ENGINEERING CHANGE NOTICE

Proj. ECN B-714-115

5. Project Title/No./Work Order No. B-714/ER8007
Grouted Waste Diposal Facilities

6. Bldg./Sys./Fac. No.
218-E-16

Ref. Dwg. H-2-77640

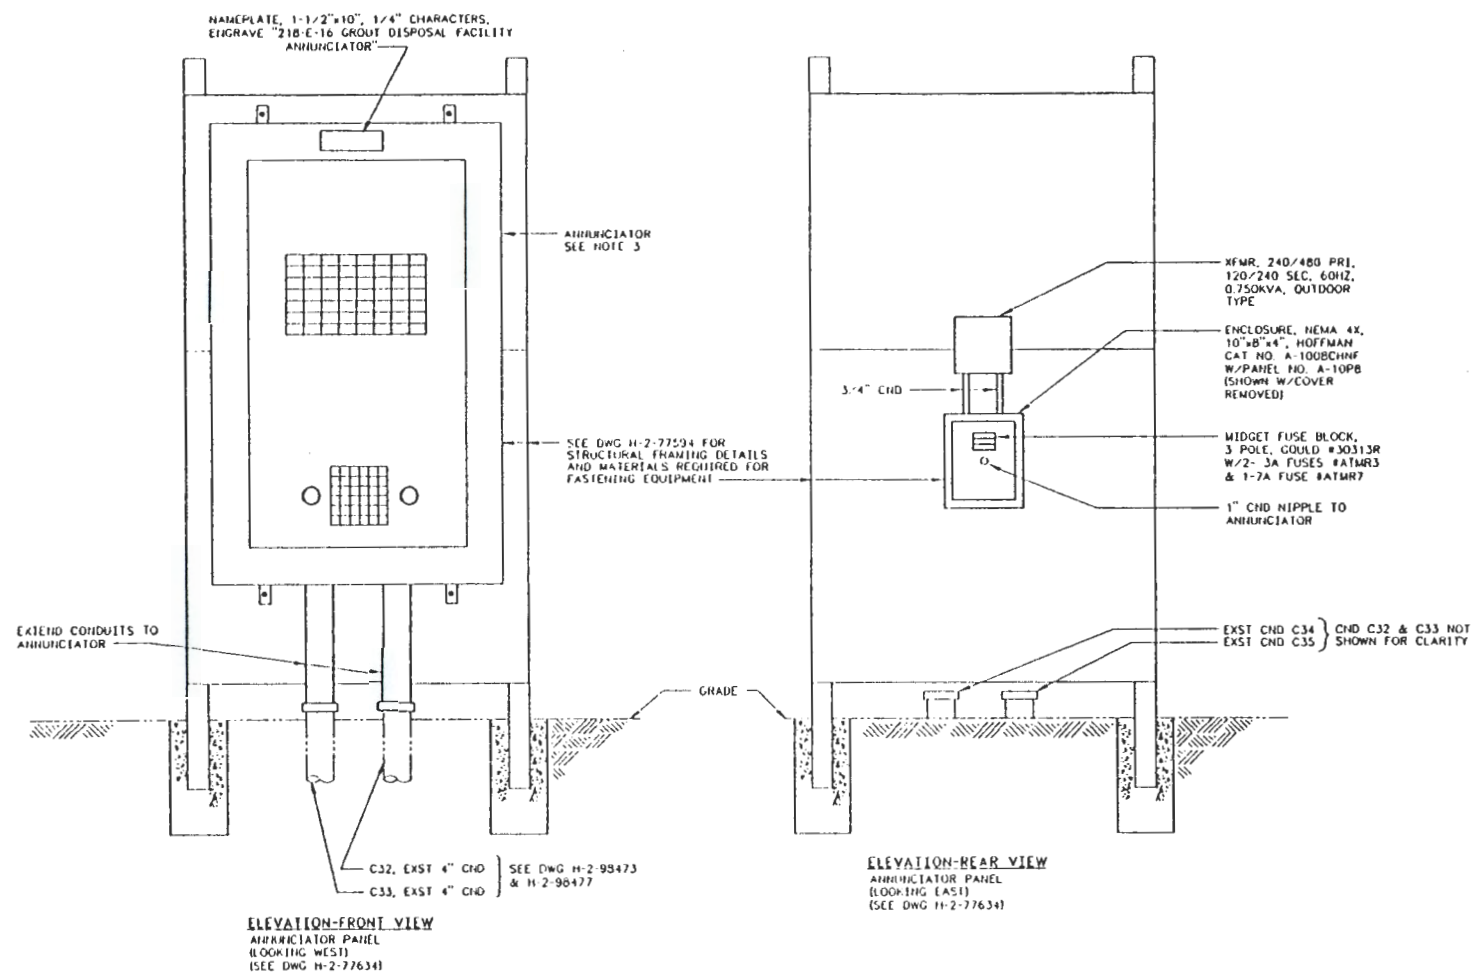
(sc-2) (Z C1-F4): Replace Elevation B & C with new elevations as shown on page 14 of this ECN.

Ref. Dwg.
H-2-77643

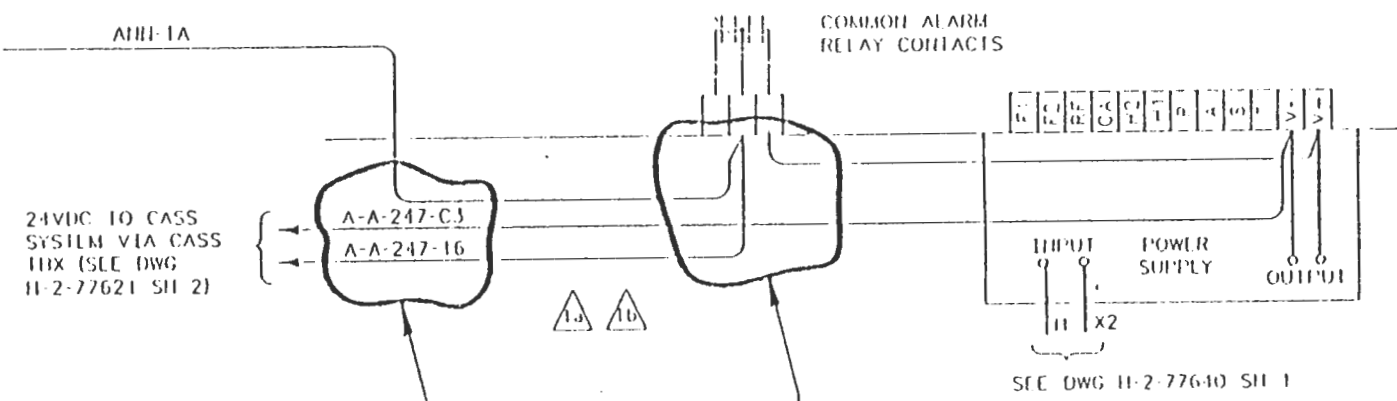
(sc-2) (Z A7): Modify - see page 15 of this ECN.

Ref. Dwg.
H-2-78504

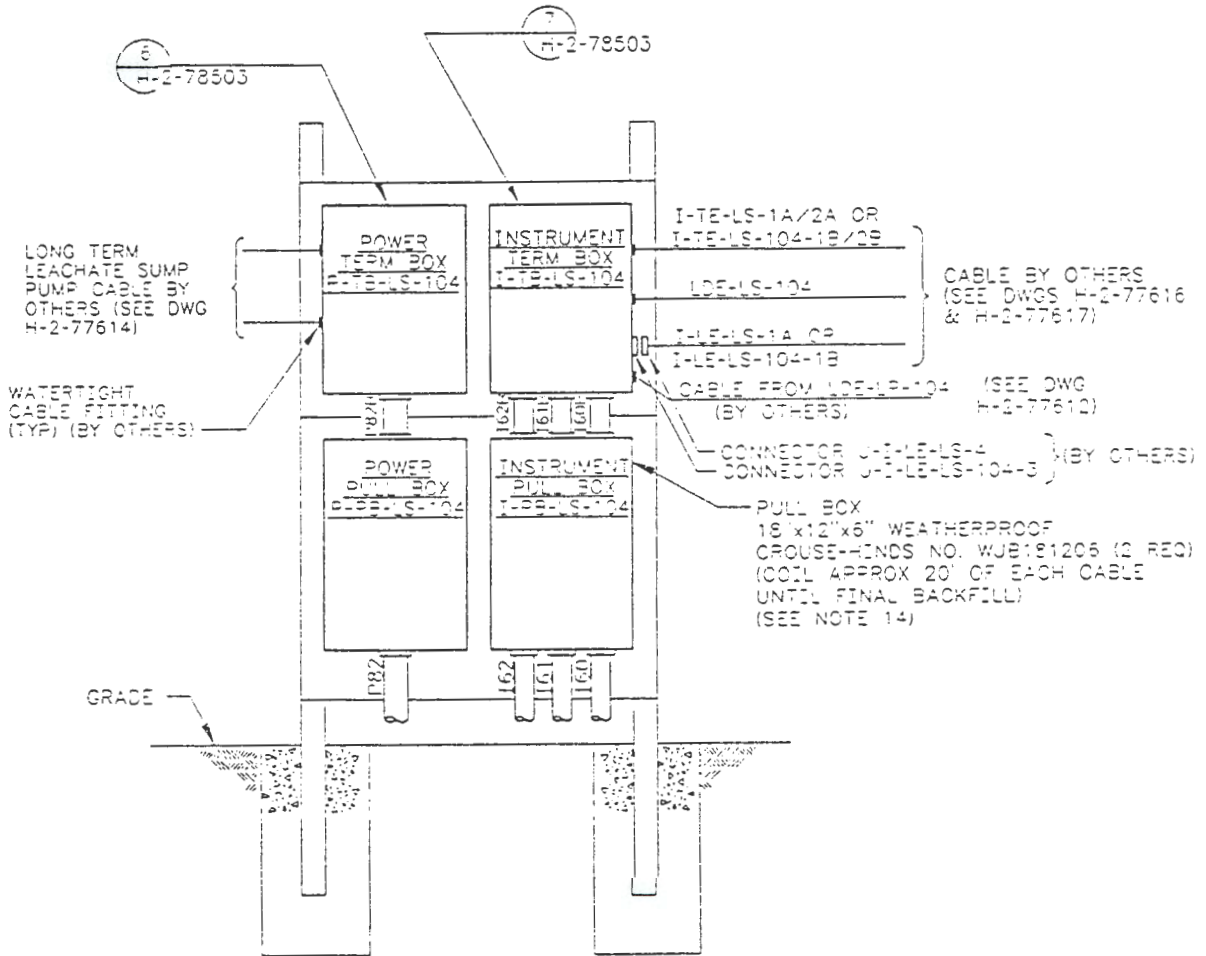
- (sc-2) A) Elevation J (Z E3-F4): Replace with new elevation as shown on page 16 of this ECN. (Incorporates ECN B-714-95, page 10, item 41)
- (sc-2) B) Elevation K (Z E1-F2): Replace with new elevation as shown on page 17 of this ECN. (Incorporates ECN B-714-95, page 10, item 41)
- C) (Z D5-F8): Delete Enlarged Plan 1 & Section T in their entirety. (Duplicate transformer details. Required information shown in ECN B-714-111, page 9)

Vault 104 Leachate Pit Rack
(SEE DWG H-2-77594 FOR STRUCTURAL FRAMING DETAILS AND MATERIALS REQUIRED FOR FASTENING EQUIPMENT)

Ref. Dwg. H-2-78505	Sh. 1	Rev. 2	Prepared By TE COYNE	Checked By 4-2-92 <i>R.K. Newhouse</i>	ECN No. B-714-115	Page 18/19
------------------------	----------	-----------	-------------------------	--	----------------------	---------------

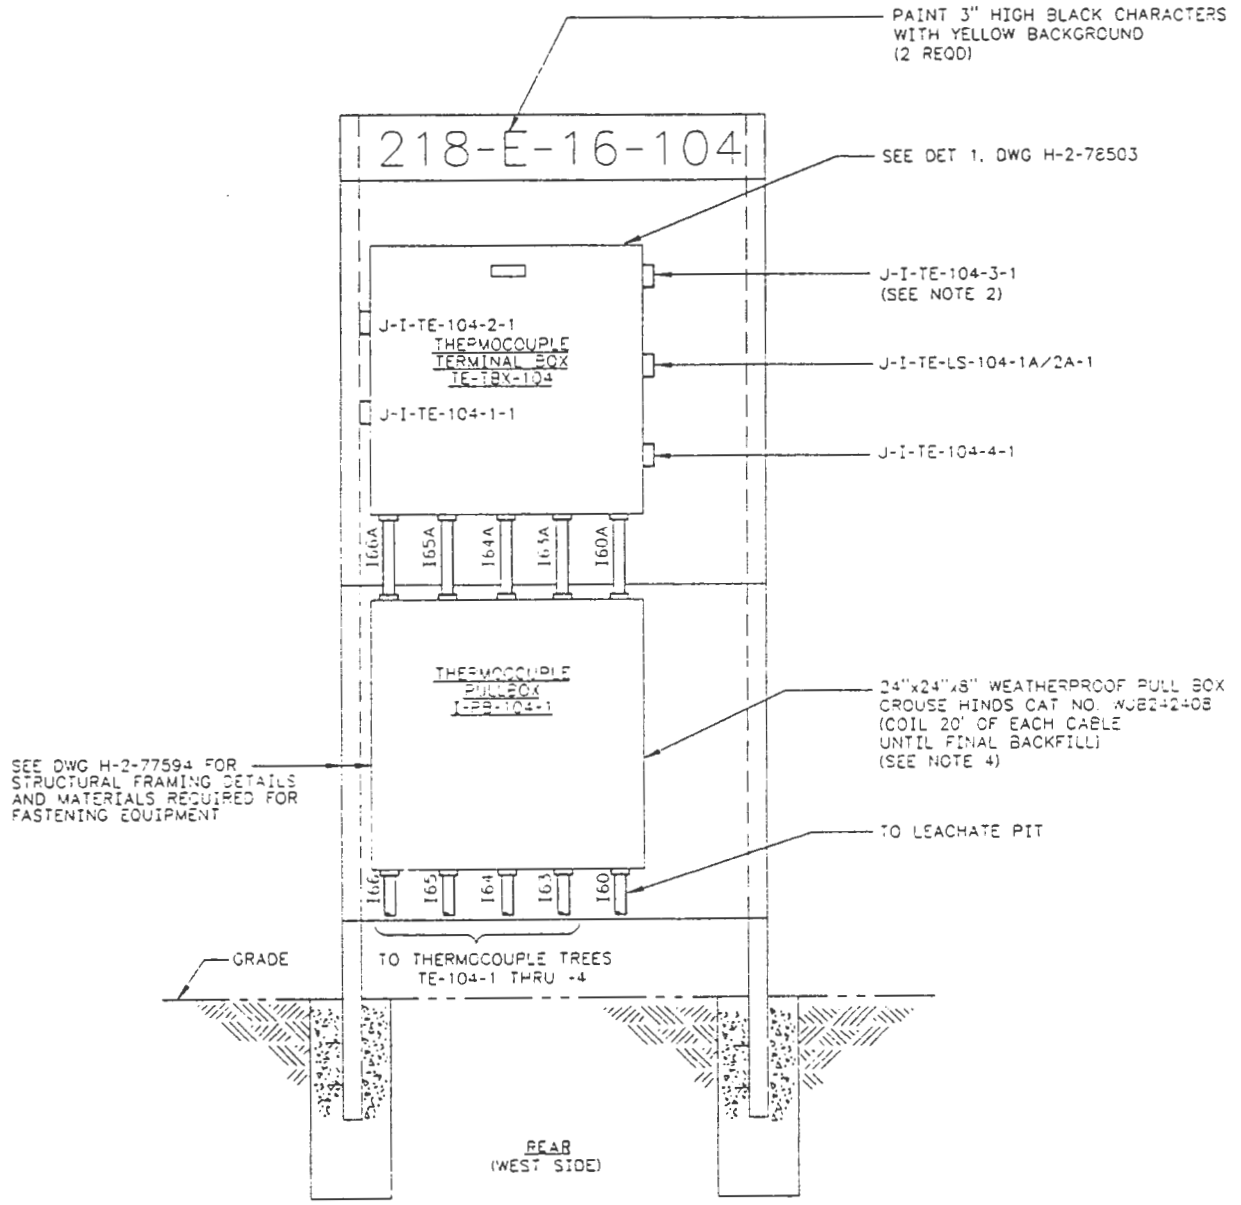
- (sc-2) A) Elevation, Front (Z D6-E7): Modify - see page 11 of this ECN.
- (sc-2) B) Elevation, Rear (Z C3-E5): Replace with new view as shown on page 18 of this ECN.

Ref. Dwg. H-2-78505	Sh. 2	Rev. 2	Prepared By TE COYNE	Checked By R.K. [Signature] 4-2-92	ECN No. B-714-115	Page 19/19
------------------------	----------	-----------	-------------------------	---------------------------------------	----------------------	---------------

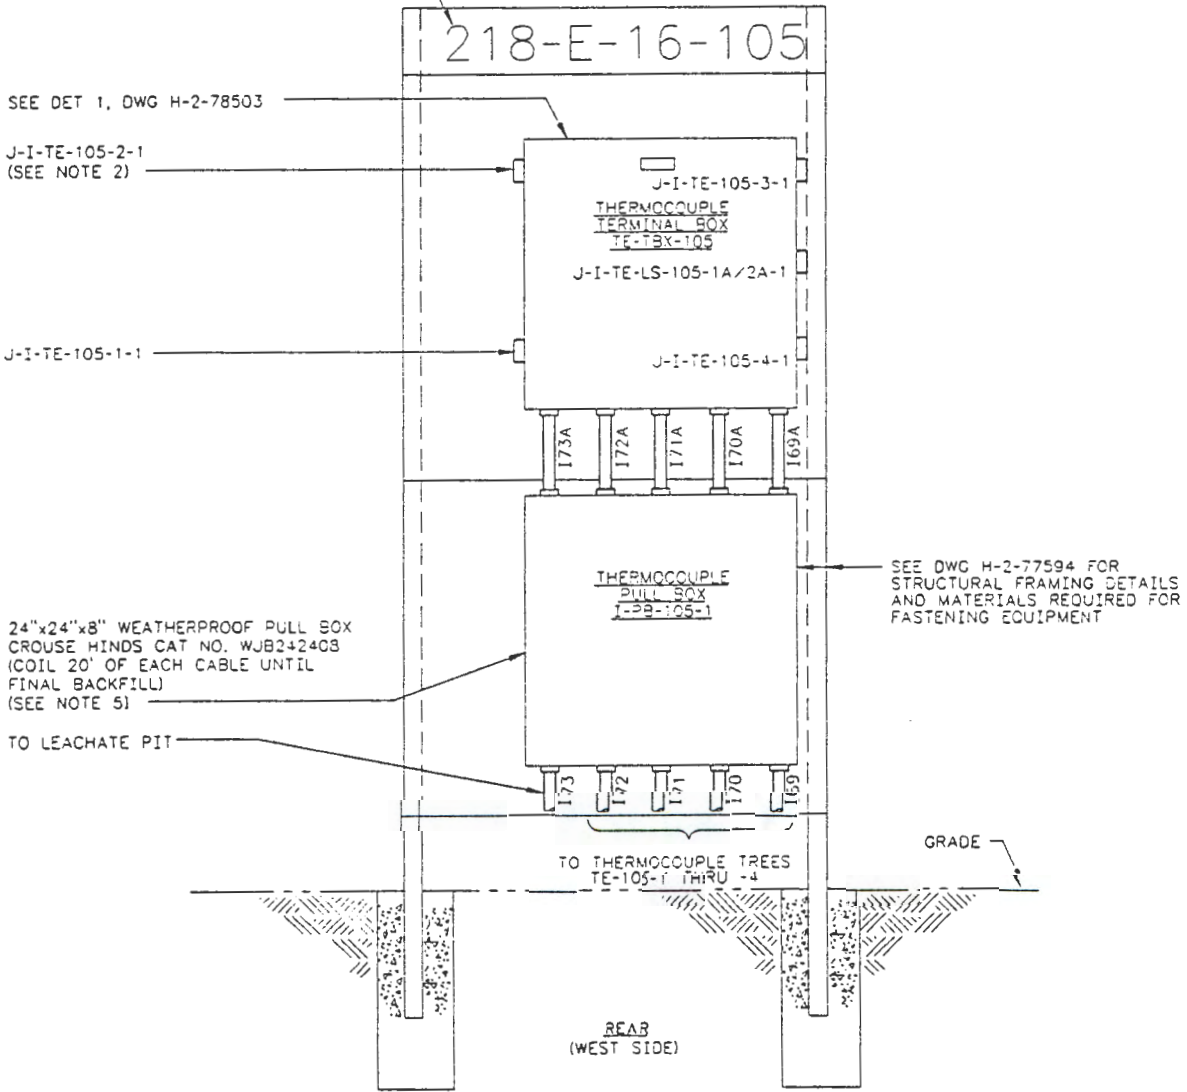
- (sc-2) A) Elevation, Front (Z C6-E7); Modify - see page 11 of this ECN.
- (sc-2) B) Elevation, Rear (Z C2-E4): Replace with new view as shown on page 19 of this ECN.
